LETTER OF SUBMITTAL
KFM Skyway Project # 04-012024

SUBMITTAL No: KFM-SUB-003590

Subject: USI - Documents Clearing KFM NCR #74 (METS #60)

Subject: USI NCR No. 60: Failure to Maintain Dimensional Tolerance for Flatness

Deck Plate Assembly pa9

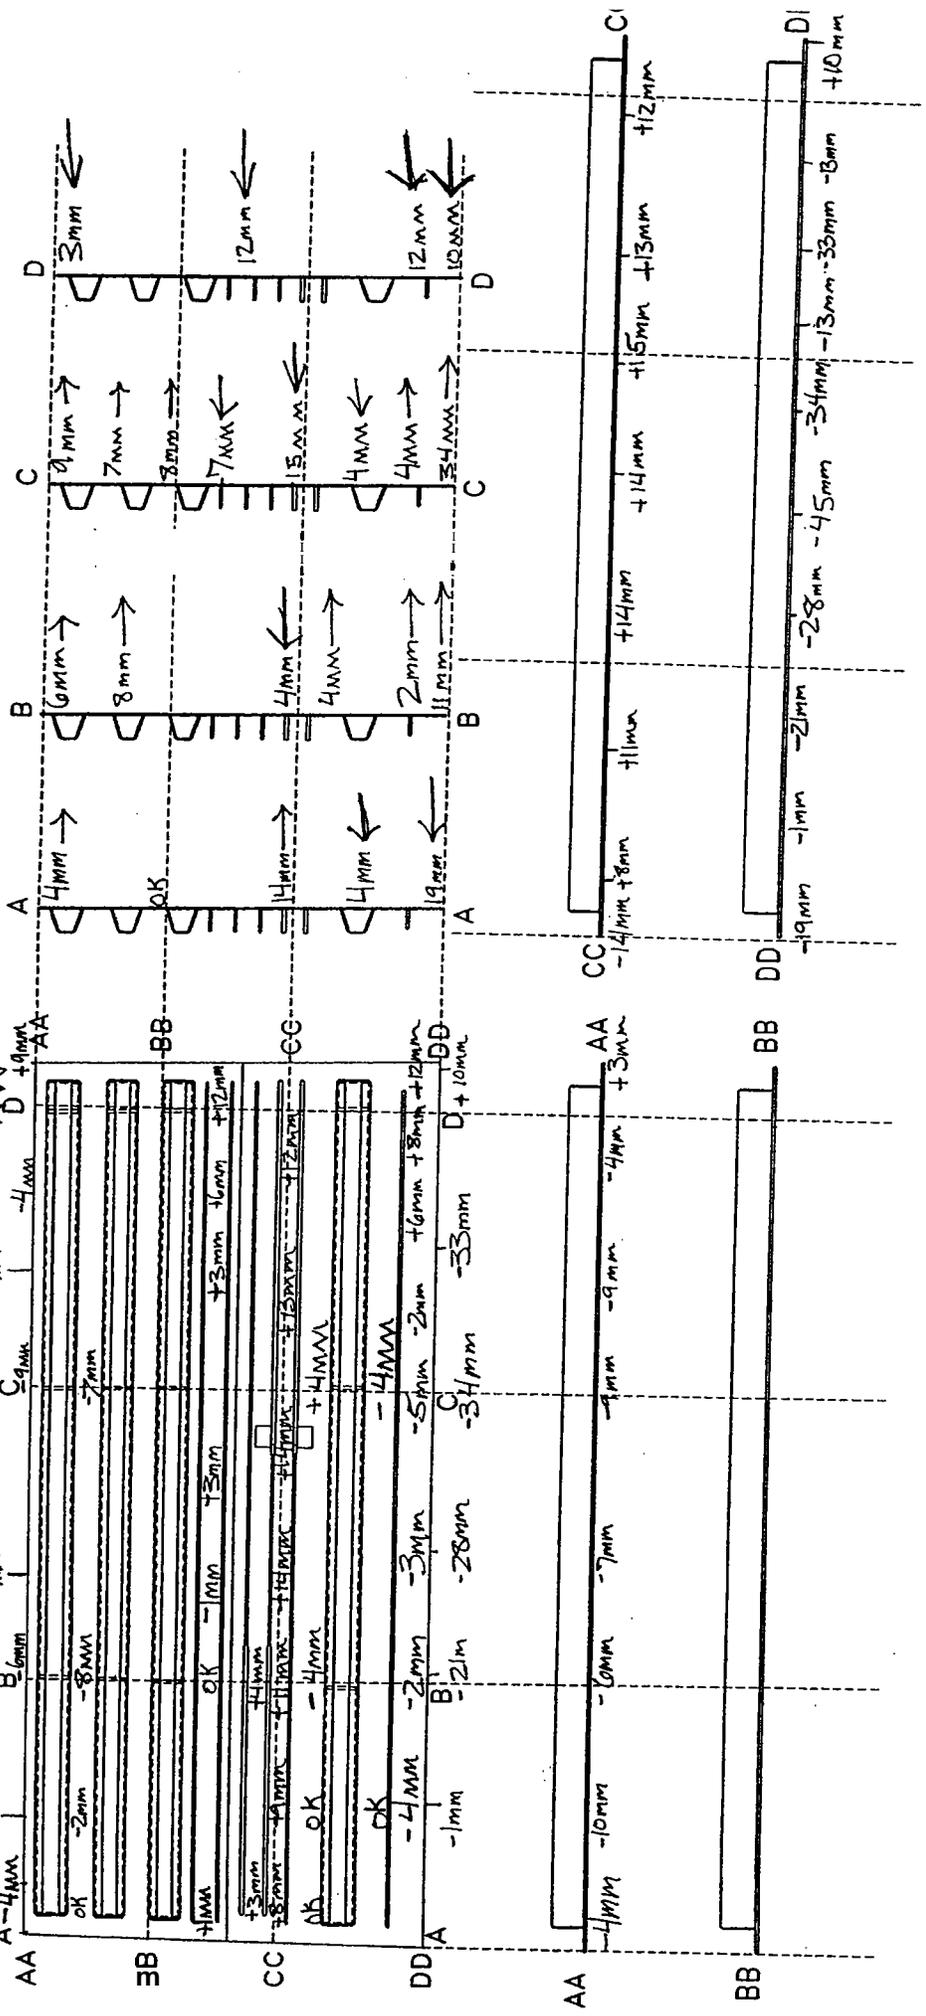
Deck plate pa9 exceeds the contract dimensional tolerance (5 mm) for out of flatness distortion. The magnitude and extent of the distortion observed concerns the State. The distortion represented is excessive and indicates poor planning. The Contractor should conduct a thorough review of their Distortion Control Plan to ensure such distortion in the future is eliminated or at least minimized. Pa 9 is hereby rejected until a satisfactory proposal is received from the Contractor to bring the material back into conformance with the contract requirements.

Step 1 - Details of Incident:
<i>Deck R Pa 9 has web distortion. The accompanying survey represents high & low points as surveyed with a laser level. Bigger numbers are high spots, Lower Numbers are low spots</i>

At the time this NCR was written, the pa9 Deck Panel was not supported in its final position. All welding had to be performed with the panel inverted in order to weld in the flat position. Once all welding had been completed, the panel was turned over and checked for flatness. Since approximately 115 weld passes had to be applied to one side of the panel and it was the first of this type to be built, there was an extremely high possibility that distortion would be encountered.

USI Incident Report No. 132 was written which brought about Heat Straightening Request 47 and 47 revisions 1 and 2. This **HSR** was labeled KFM no. 3307 and was approved by Caltrans. **If** the distortion had been as bad as State letter no. 5.03.01-006110 indicates, it is highly unlikely that acceptable flatness measurements would have been achieved in two (2) heat cycles as illustrated on HSR 47.

Deck Plate Assembly pa9

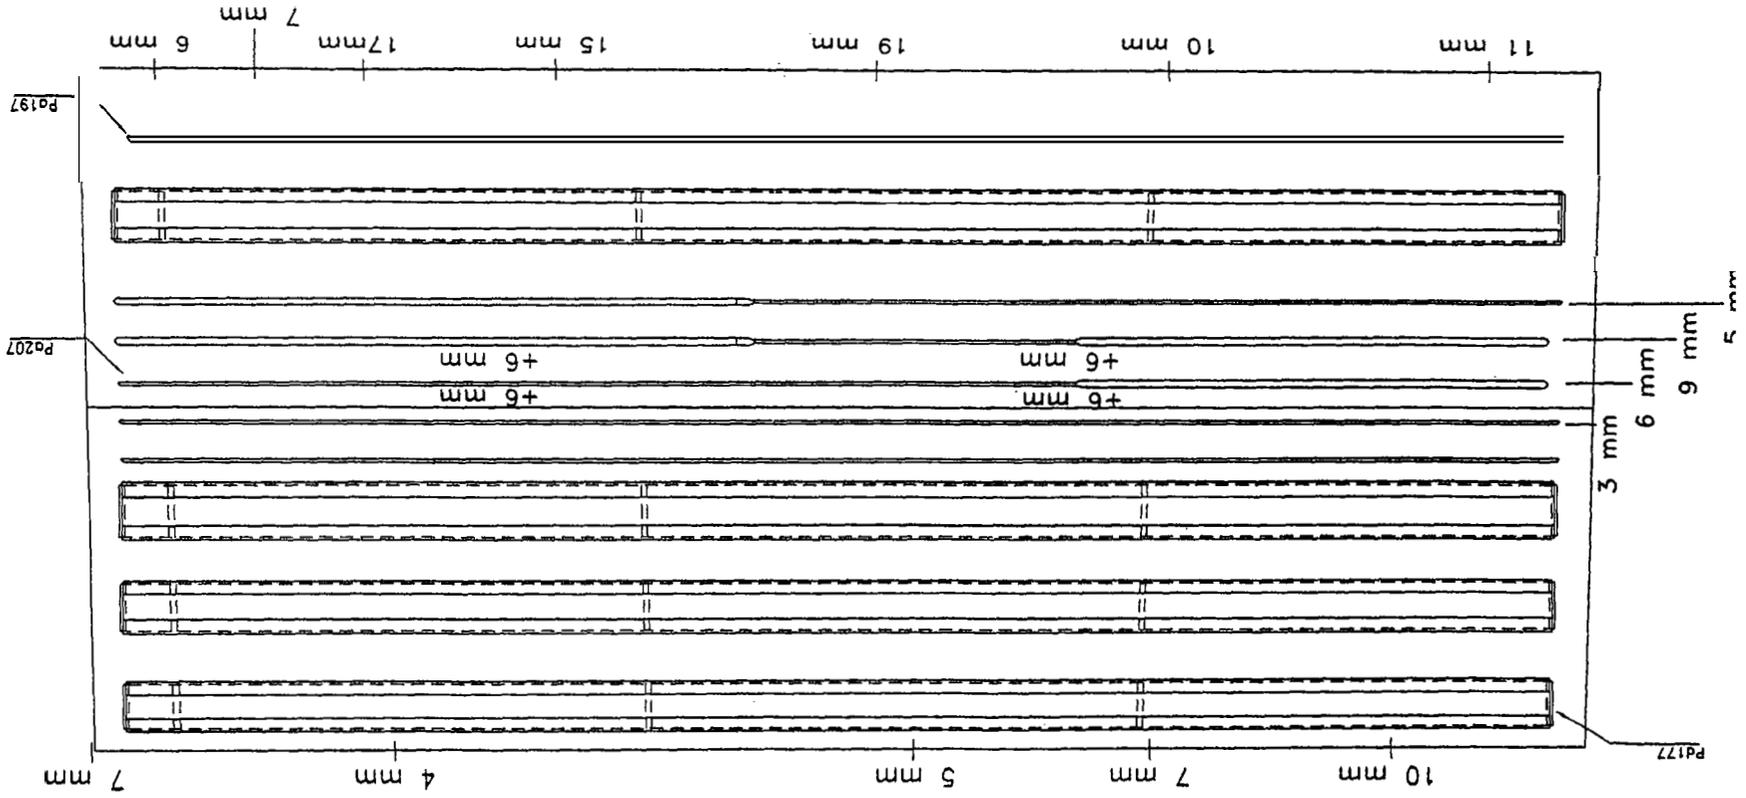
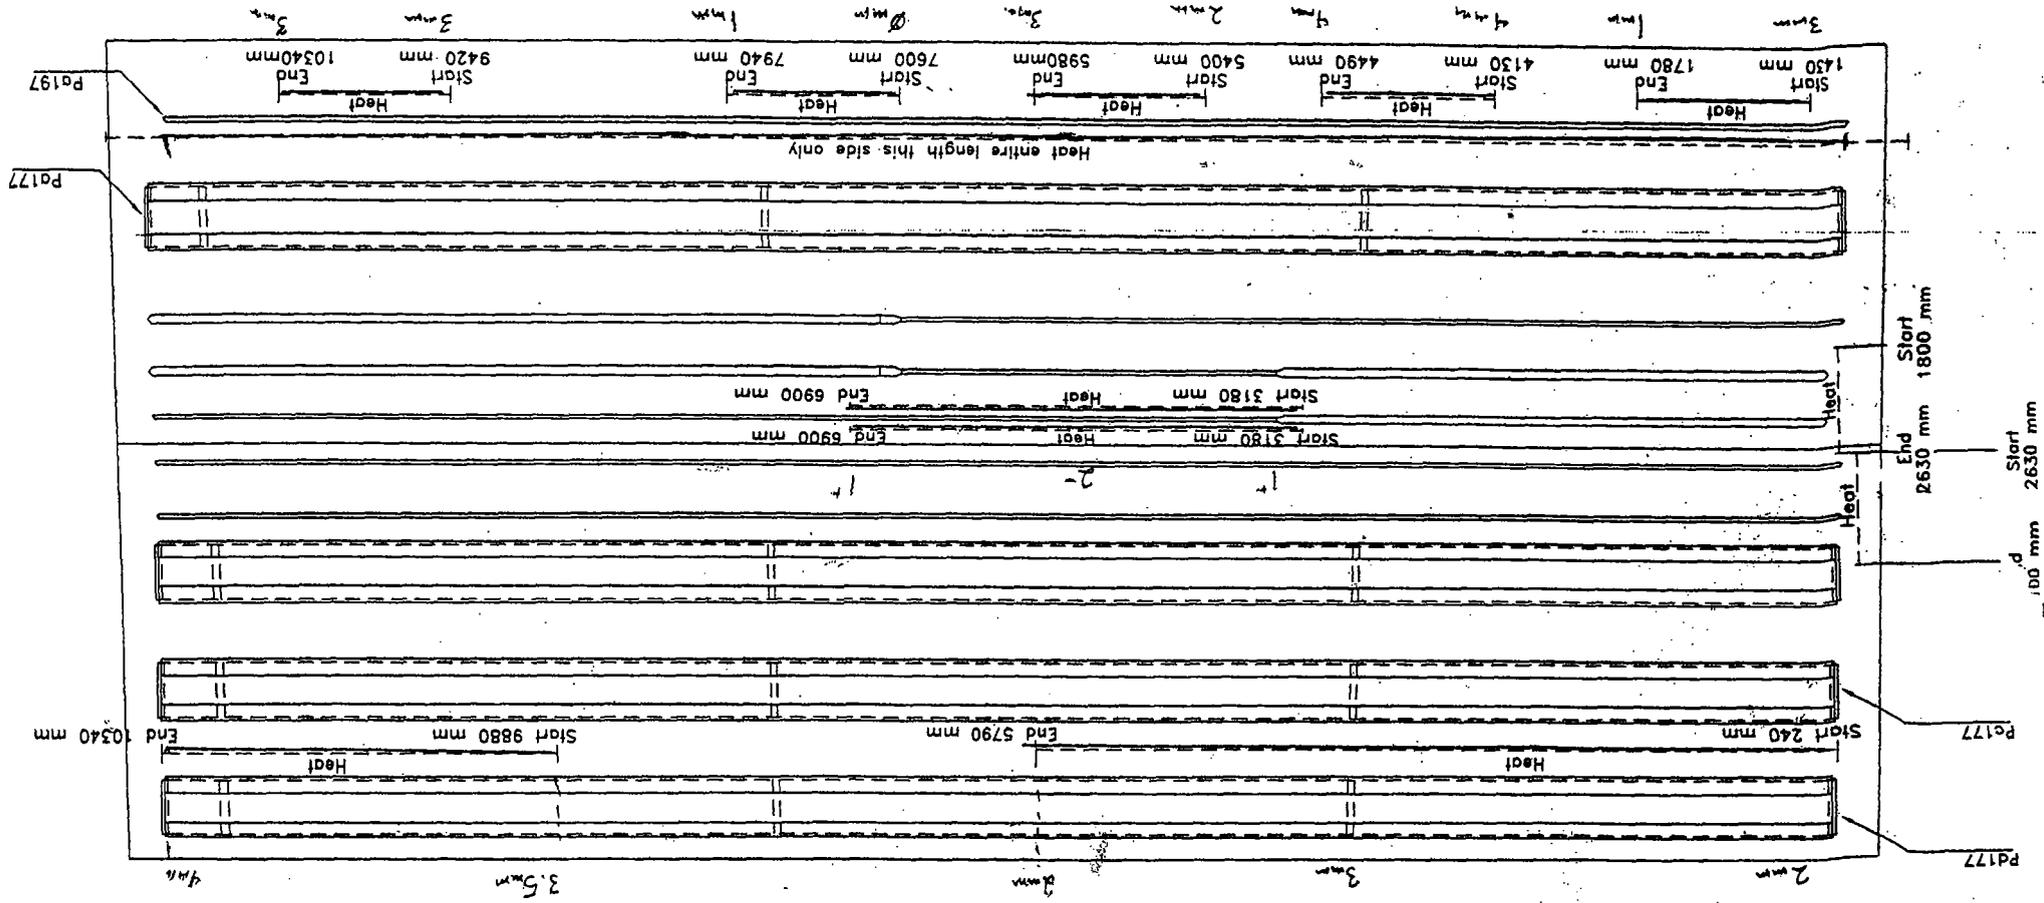
The Engineer **has** reviewed KFM-SUB-003307R02: USI Heat Straightening Request 04-47 Rev.2 regarding requests to heat straighten **deck** plate pa9. The subject submittal is approved **with** concerns. The Engineer will allow USI to apply one additional progression of heat. Heat **straightening** should occur in the presence of a State QA inspector. Subsequently, nondestructive **testing** (NDT) shall be **performed** in accordance with AWS D1.5 Section 6.7.3.

The Engineer is concerned KFM has not developed adequate distortion control measures and/or made sufficient **adjustments** to the fabrication procedures to minimize such distortion in the future.

Deck Plate Pa 9 has distortion caused by welding on one side of the plate. A line heat will be applied along the bottom far side of Pa 9 parallel to Open Rib Pa 197 in five places. A line heat will be applied to the complete length of Pa 9 in between and parallel to Tendon Rib Pa197 and closed rib pa177. At the Top of Pa 9 m between and parallel to closed ribs Pd177 and Pc 177, a line heat will be applied to Pa 9 m two different areas. On the left edge of Pa9, a line heat will be applied in two different areas. See heat layouts on attached sketch.

HSR 04-47Rev. 1 was submitted with incorrect distortion check numbers on the distortion drawing. The correct numbers are on the distortion drawing attached to this HSR 04-47 Rev.2.

All application of heat to base metal shall be controlled by using Temp Sticks or Thermocouples to assure that heat does not exceed allowable. Weld joints are to be heated on the far side of Deck Plate Pa9 and parallel to the weld. This line heat will be located approximately 1 to 3 inches from the weld joint on the outside of the surface that is distorted.

Deck Plate Assembly pa9

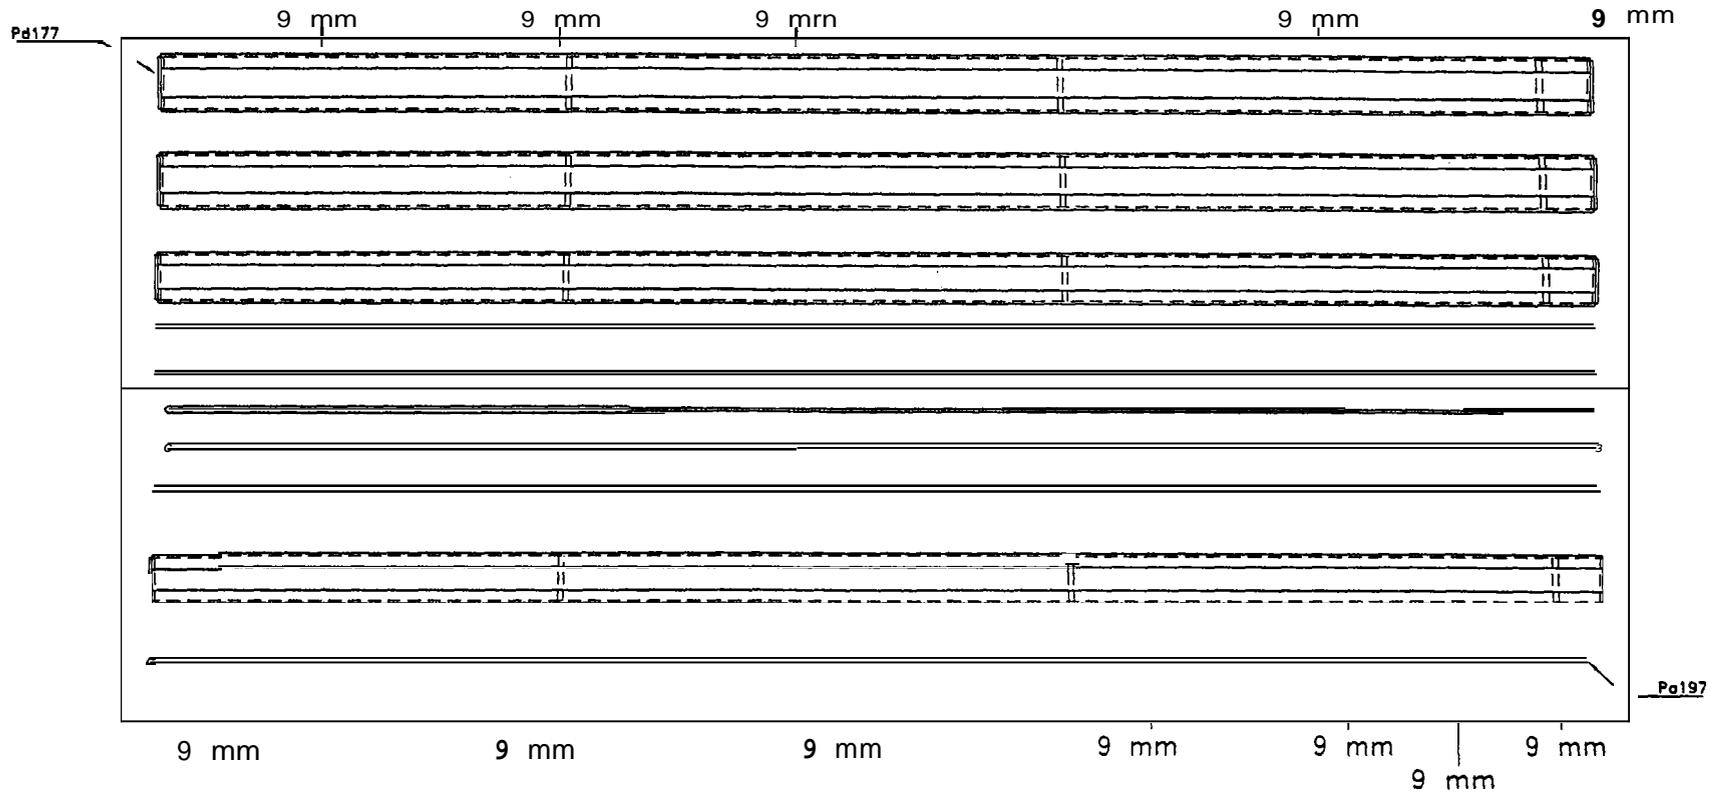
*Verbal reject from Caltrans on 11-29-04
 JS (not enough info. on distortion map)*

The Engineer **has** reviewed KFM-SUB-003307R01: USI Heat Straightening Request 04-47 Rev.1 regarding requests to heat straighten **deck** plate pa9. The subject submittal is not approved. The submittal **does** not contain sufficient information regarding the **magnitude of the** distortion. **Requests** for heat straightening should include the out of tolerance measurements **and** their respective locations.

Deck Plate Assembly pag9

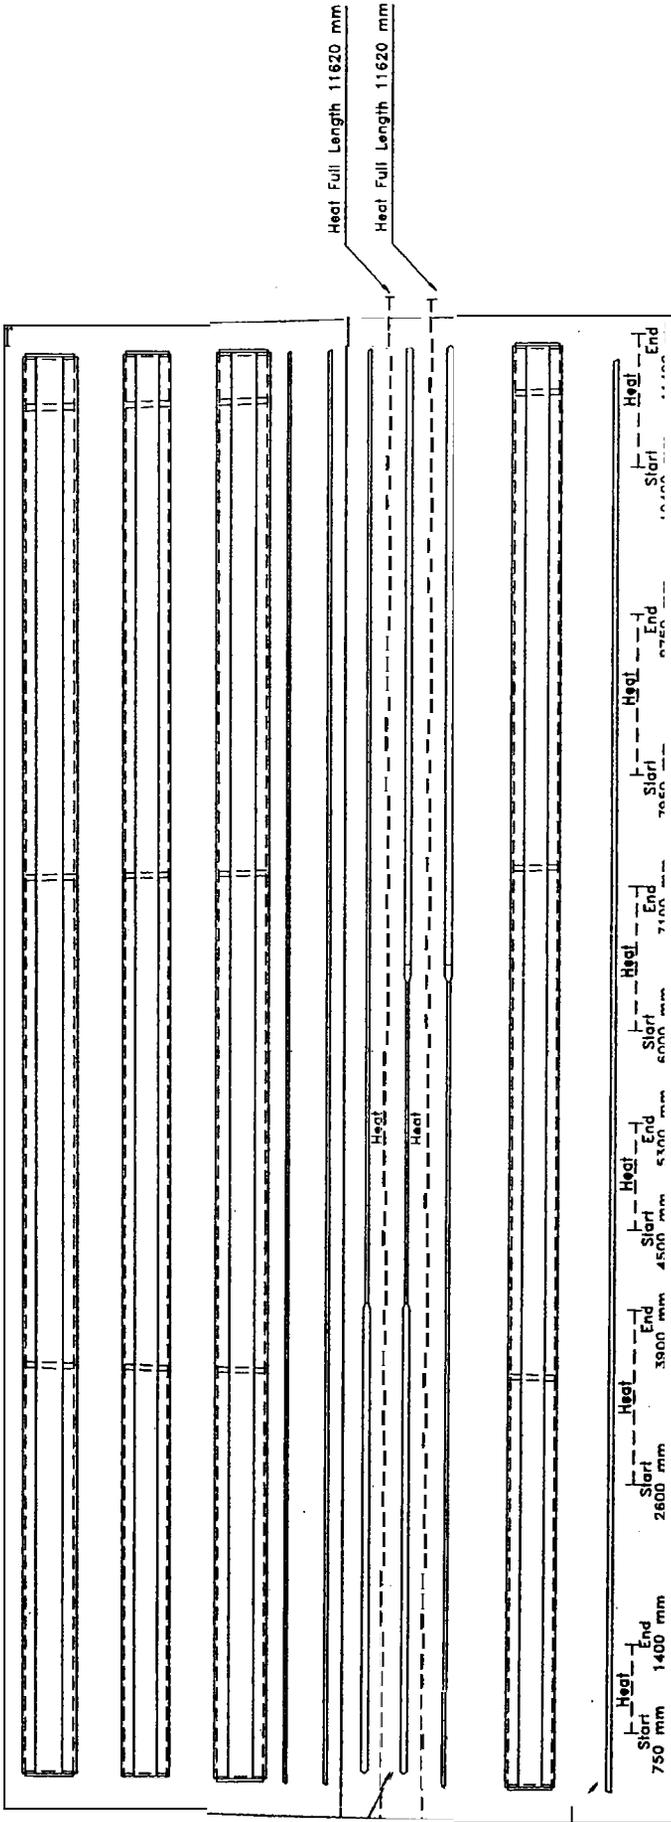
The Engineer has reviewed **KFM-SUB-003307R01: USI Heat Straightening Request 04-47** regarding **the** request to heat straighten pa9. The subject submittal **was** verbally approved on **11/23/04** with the following conditions. The Engineer will allow USI to apply one progression of heat. Heat straightening should occur in the presence of a State QA inspector. After the first progression of heat is applied, the measurements of the affected dimensions should be communicated to the State QA inspector on **the** shop floor. At this time, the Engineer may approve the second progression of heat in accordance with the submitted procedures. Subsequently, non-destructive testing (NDT) shall be performed in accordance with AWS D1.5 Section 6.7.3. Future submissions for requests to heat straighten material should include specific adjustment to USI's fabrication procedure and/or distortion control plan to minimize such distortion in the future.
